KV6\KV8 Series Villa Door Station Firmware

V2.2.53_220602 Release Note

Device Model	DS-KV6103-PE1(B)、DS-KV6113-PE1(B)、DS-KV6113-WPE1(B)、DS-KV8113-WME1(B)、 DS-KV8213-WME1(B)、DS-KV8413-WME1(B)
Firmware Version	V2.2.53_220602
iVMS-4200 Version	Latest version
Hik-Connect APP	Latest version

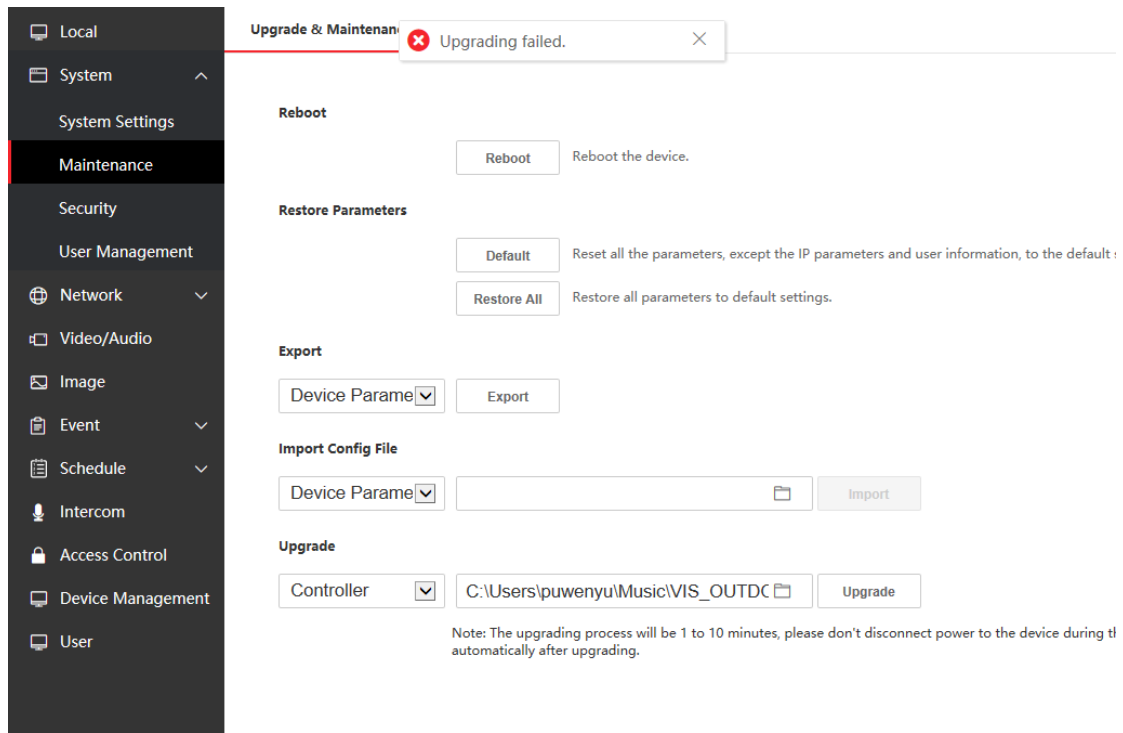
2、 Newly support for French voice prompt "calling", "the line is busy" and "the door is open"
3、 The method of adding sub door station is changed to the same method as protocol 1.0. (Fill in the Main Door Station IP and Registration Password in the configuration interface of Sub Door Station)

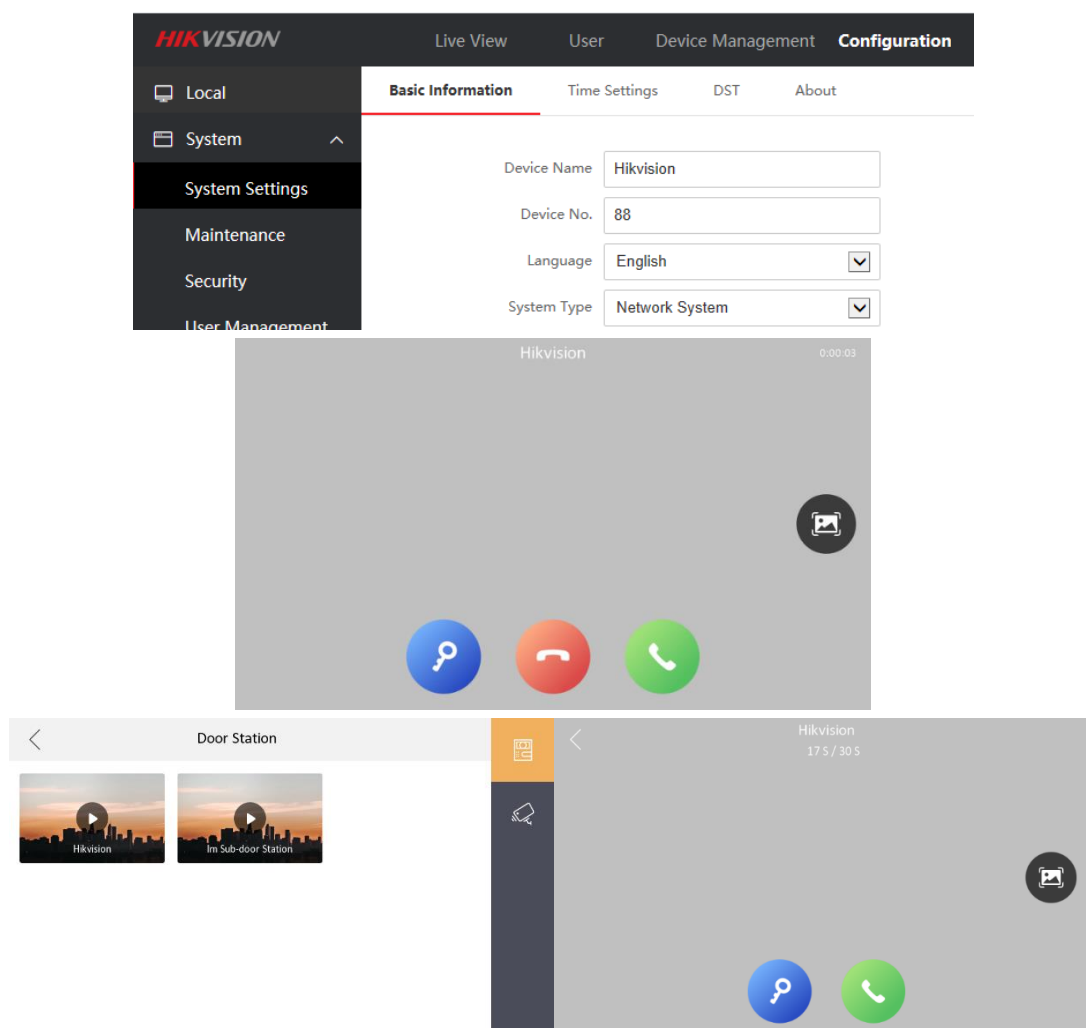
1. The changed name of the door station will be displayed on the call interface or live view interface of the indoor station

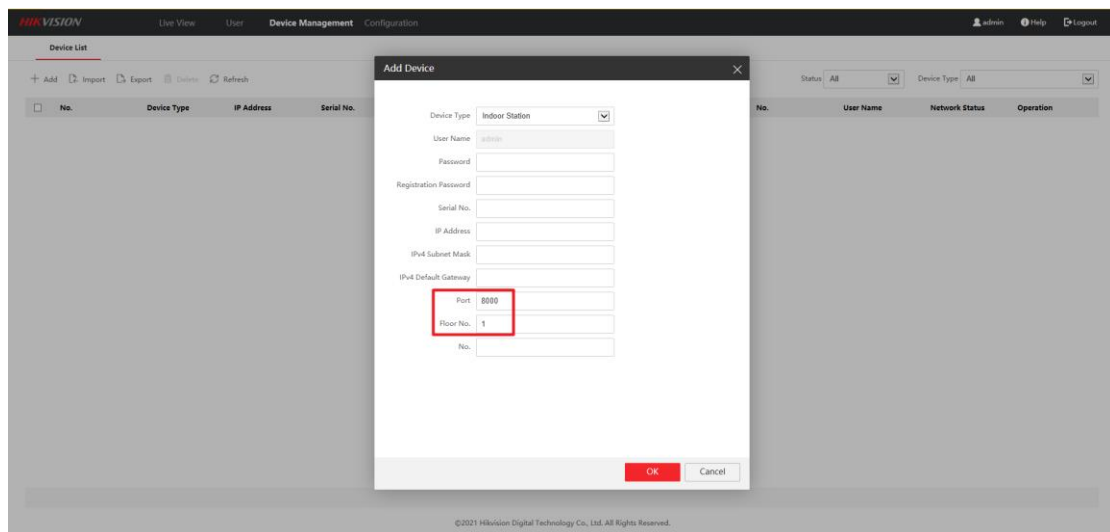
2. Add indoor station or sub-door station to iVMS-4200 or WEB to add default value

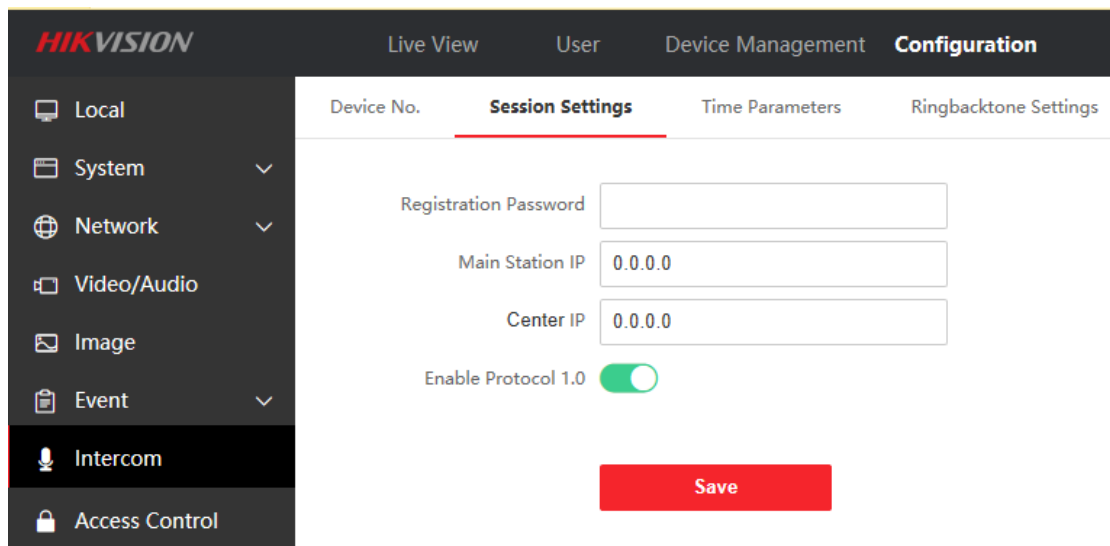
3. If the Registration Password in the door station WEB interface has been configured, it will be displayed in cipher text
4. Video Intercom Server IP (Private SIP server IP) naming changed to Center IP

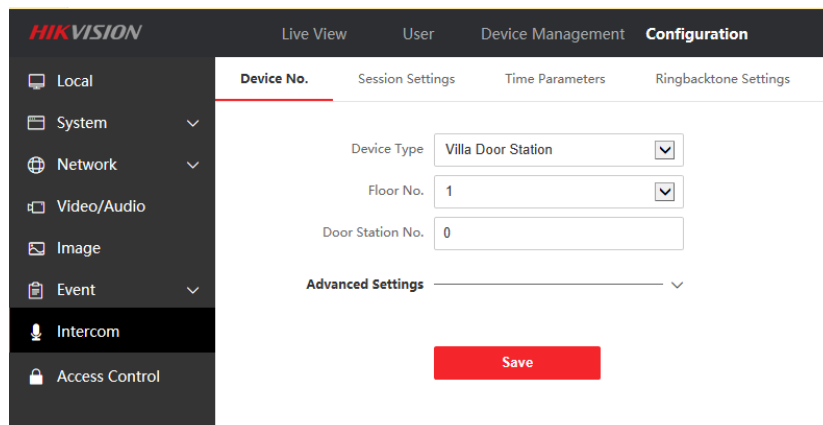
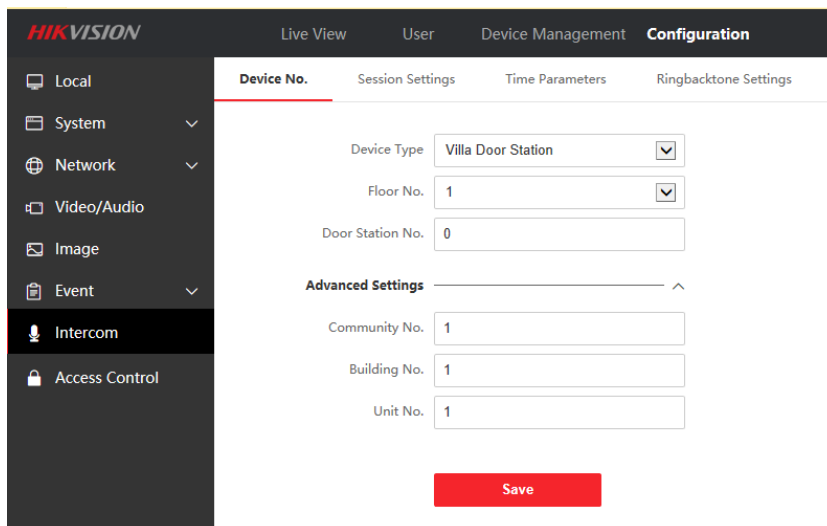
5. The WEB or iVMS-4200 interface community number, building number, and unit number of the door station will be stored in the advanced settings column instead of being displayed directly

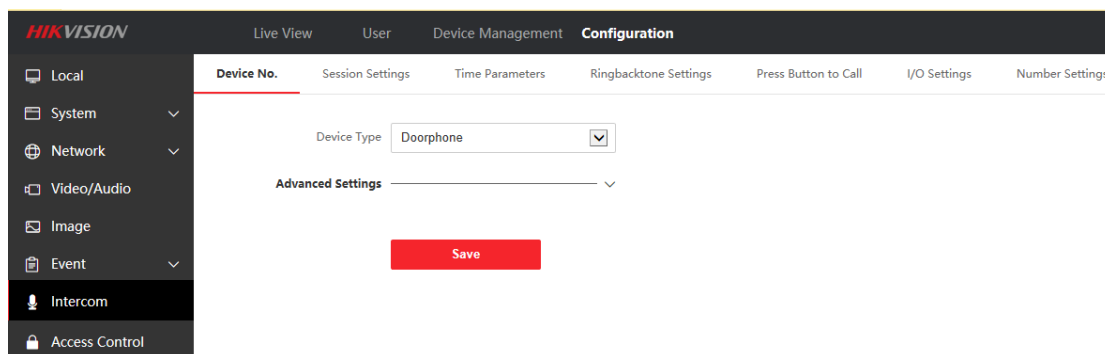
6. Support doorphone mode, when this function is enabled, the door station will no longer actively synchronize the information of the indoor station

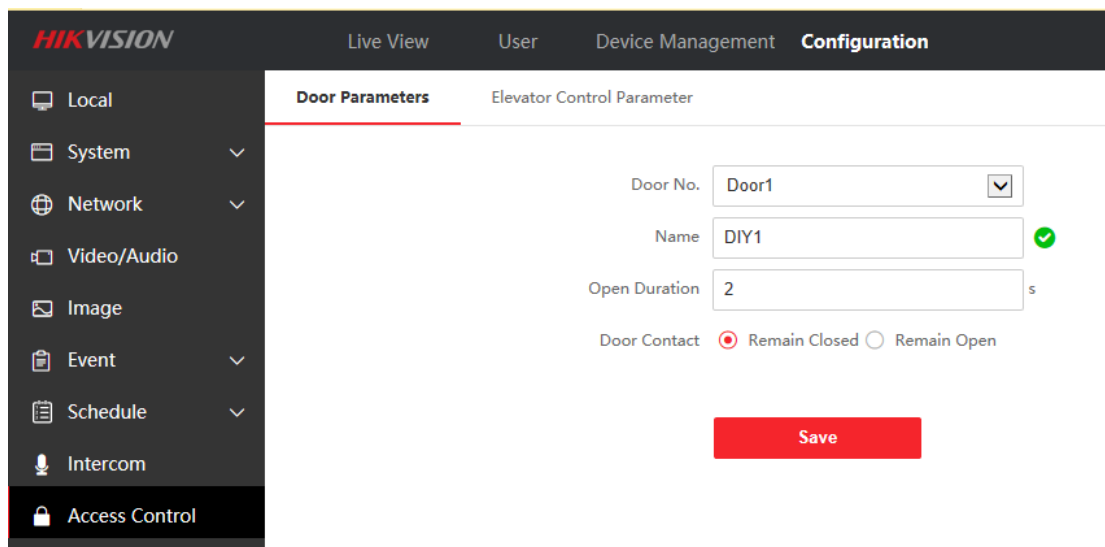
7. Both Lock 1 and Lock 2 support custom names

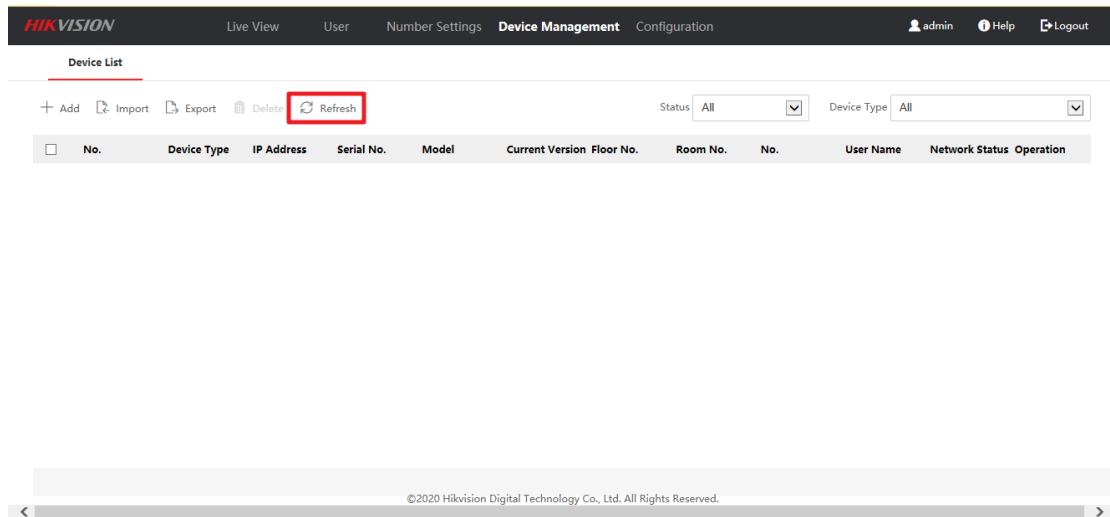
1. New refresh button is used to refresh the status of added devices

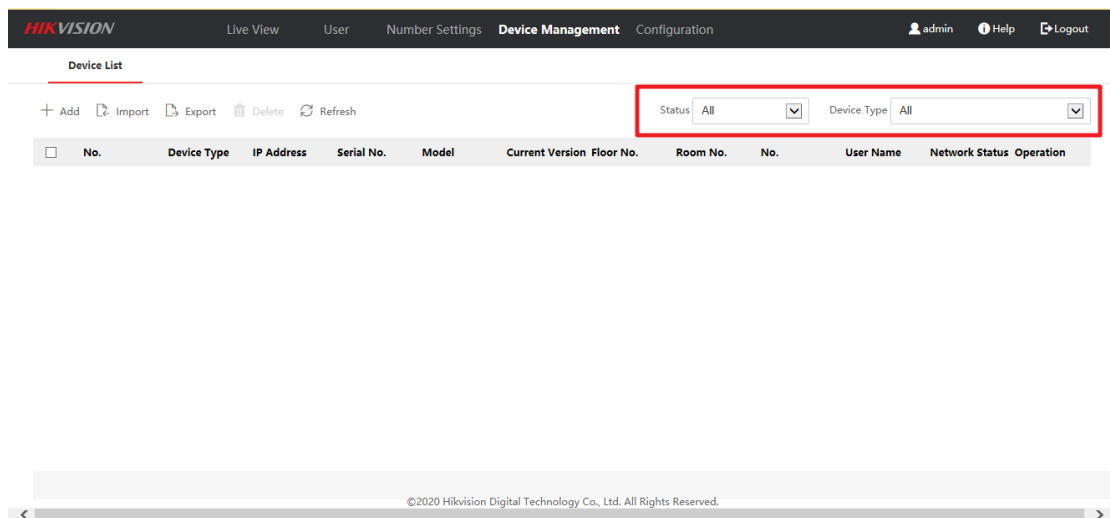
2. Added 'All' option, indoor station and sub-door station will be displayed together.

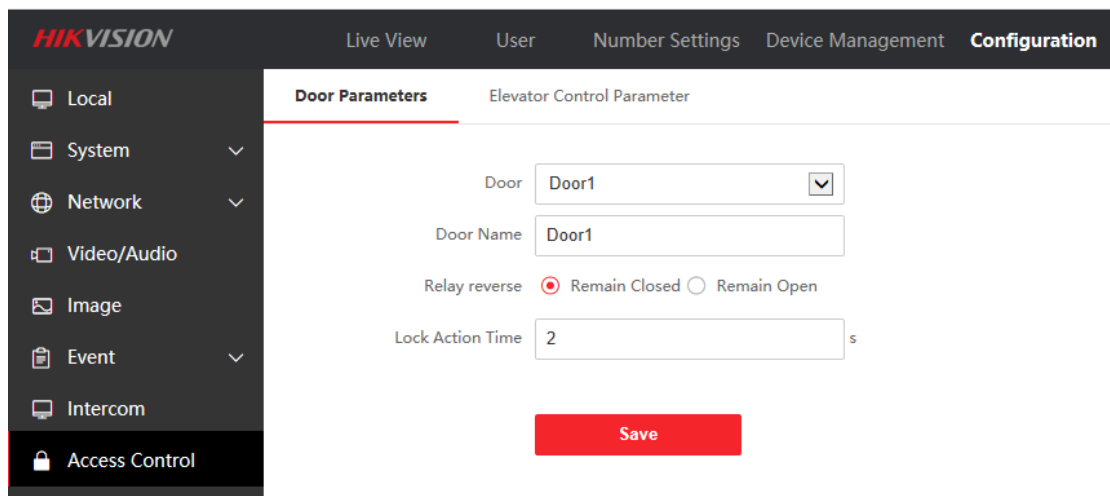
1. Modify the default unlocking time to 2 s, and supporting unlocking time can be configured with 1-255 s

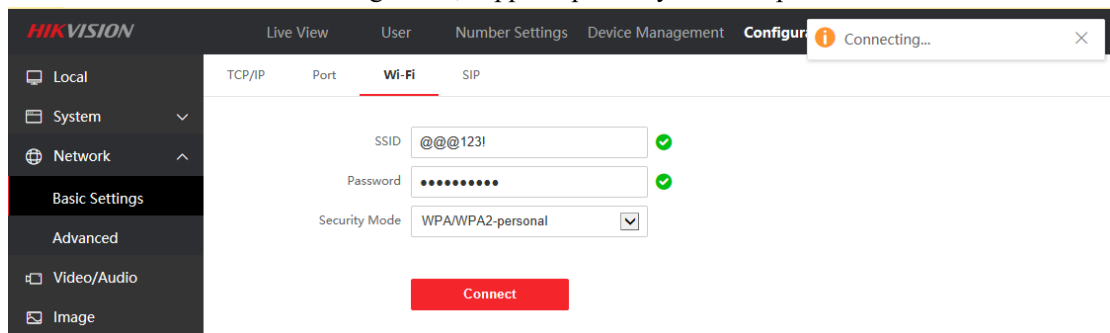
2. When villa door station adding Wi-Fi, support special symbols as password

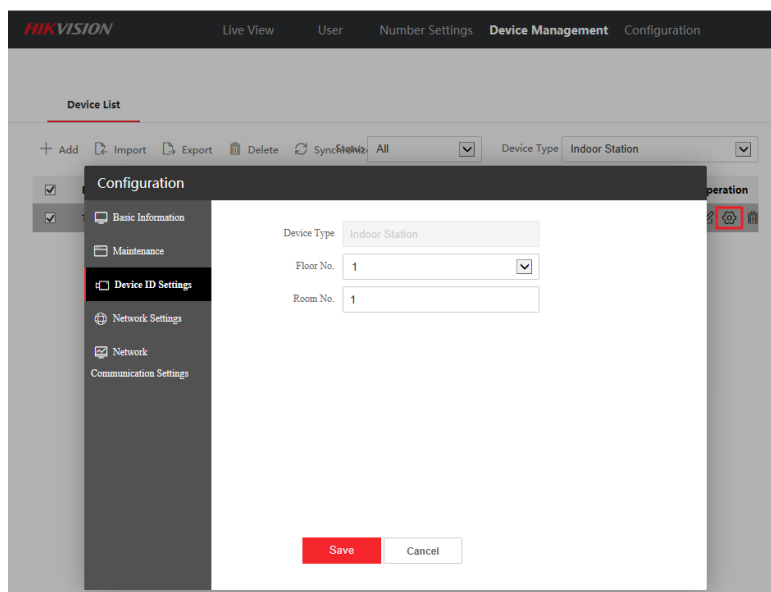
c. Support remote modification of the user password/network information/number of the indoor station on the WEB. The registered indoor station information will be overwritten after modification.

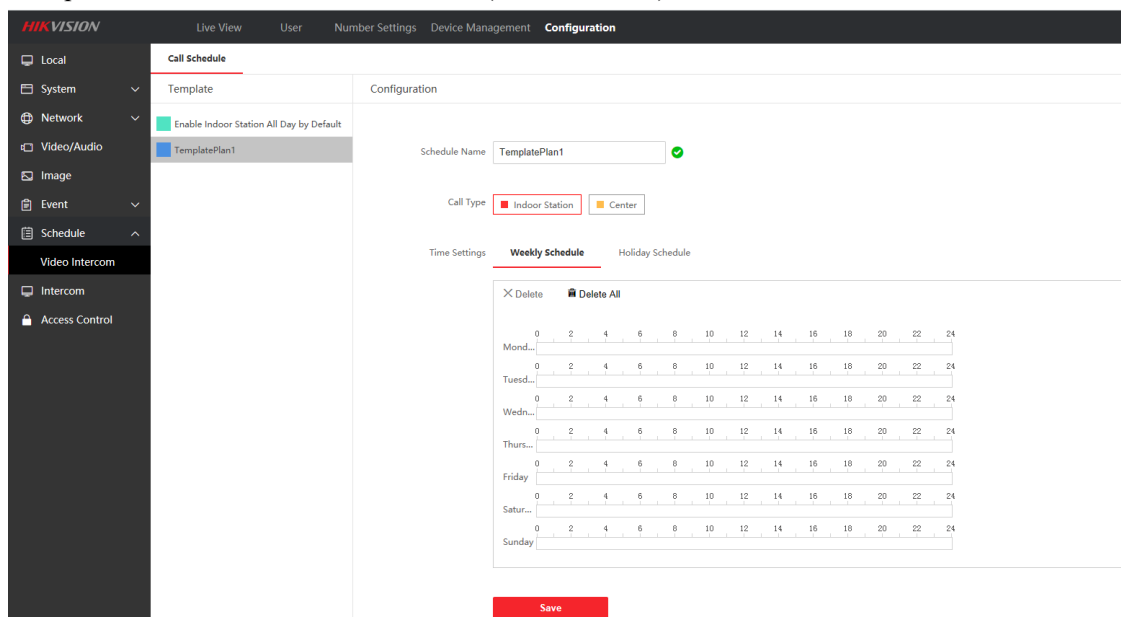
a. Call weekly plan, holiday plan support configuration: 1. Time period 2. Button call object of each time period: indoor station or iVMS-4200 (Master Station)

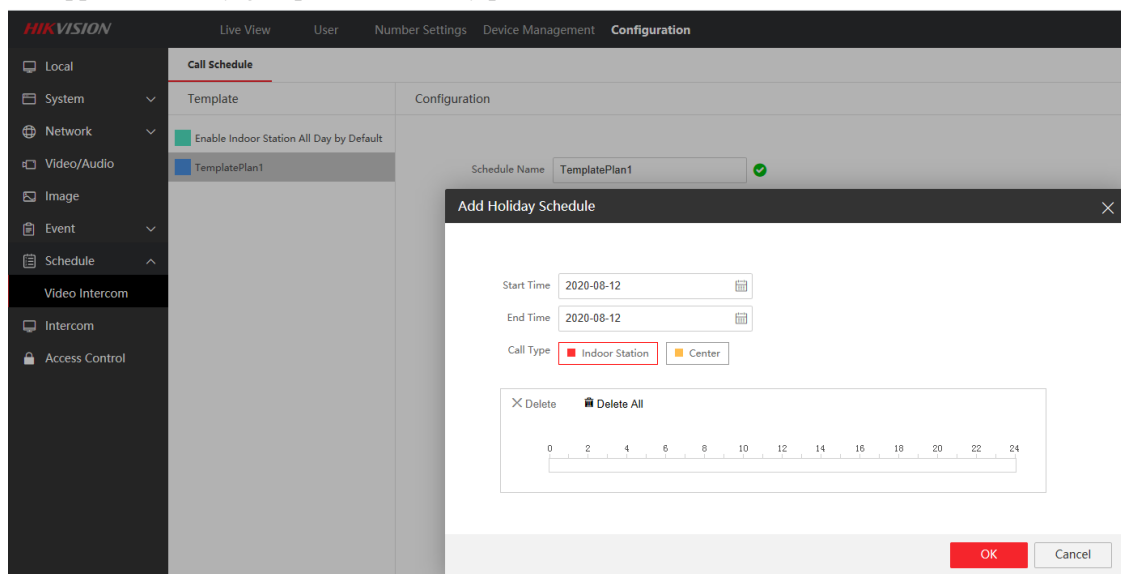
b. Support 1 holiday group and 16 holiday plans

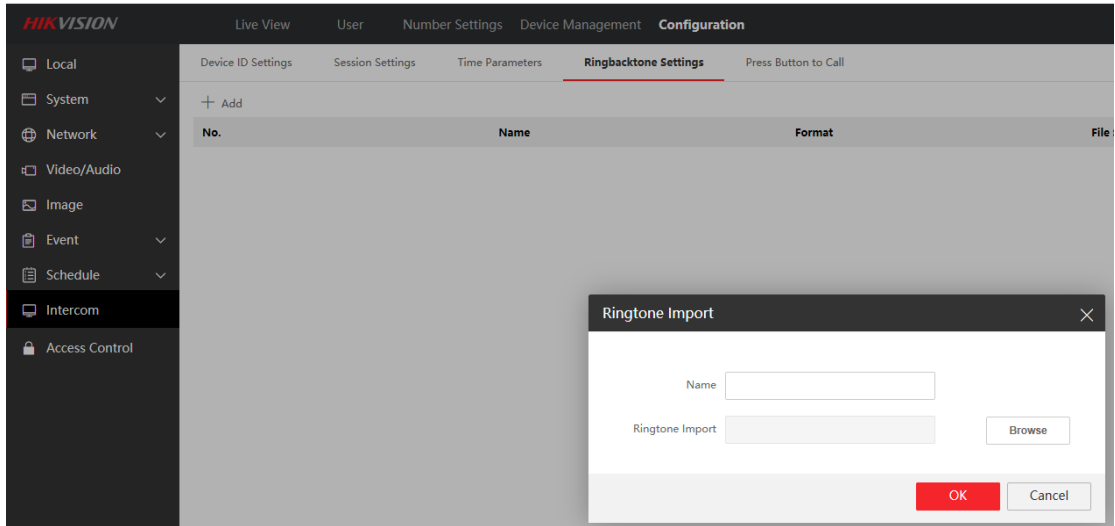
b. Quantity: Only support one ring back tone import, if it has been already uploaded, the newly uploaded ring back tone will overwrite the old ringtone

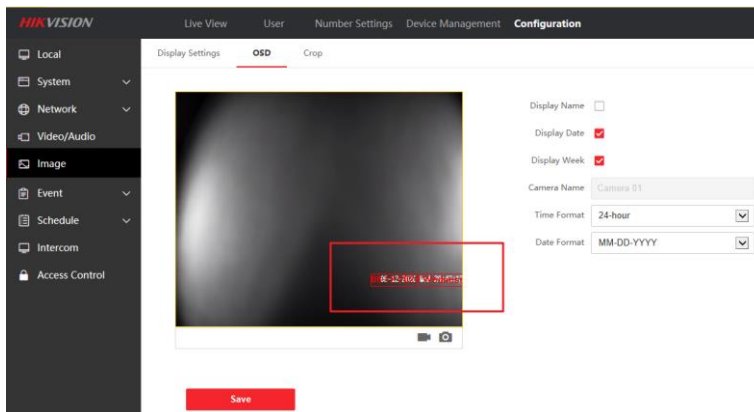
a. The door station can open different locks through the external card reader (or card reader module KD-M, KD-E) different DIP Switch dial codes. When the dial code is not 2, open lock 1, and when the dial code is 2, open lock 2.

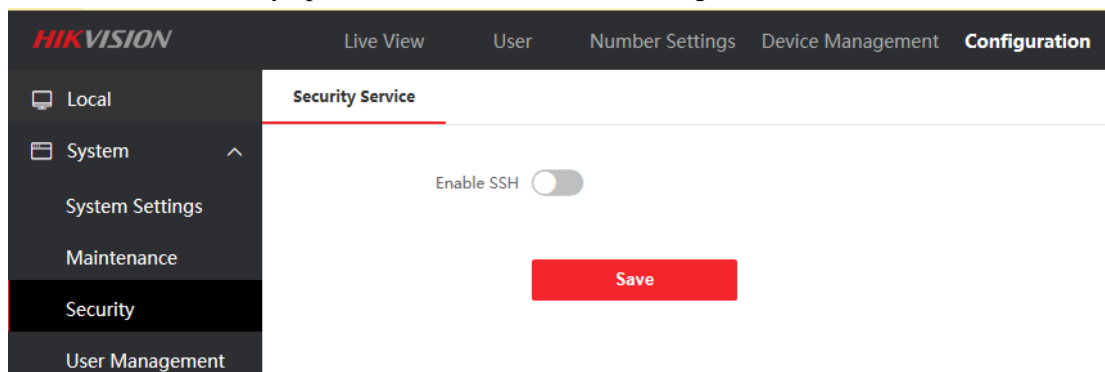
2. The default position of the OSD is adjusted to the lower right corner. When performing intercom with the master station and indoor station, the default OSD will not block the existing key information;

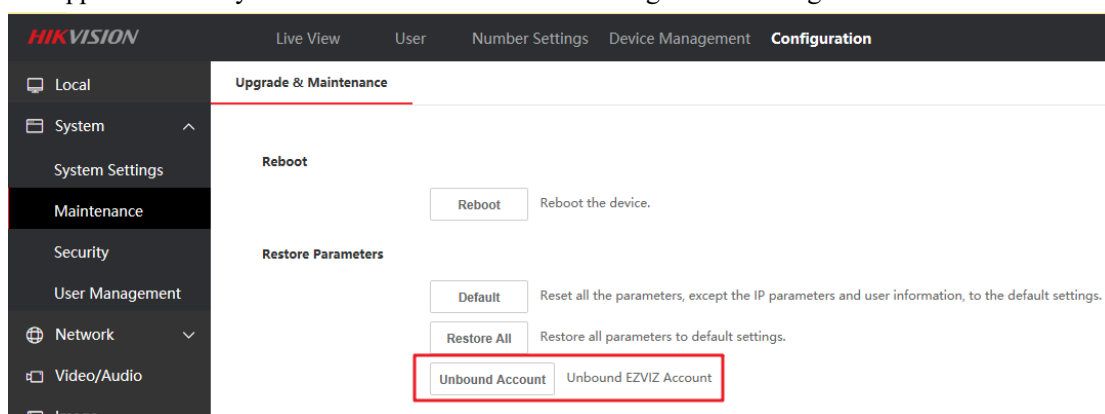
3. The user can remotely open the device SSH function through the WEB;
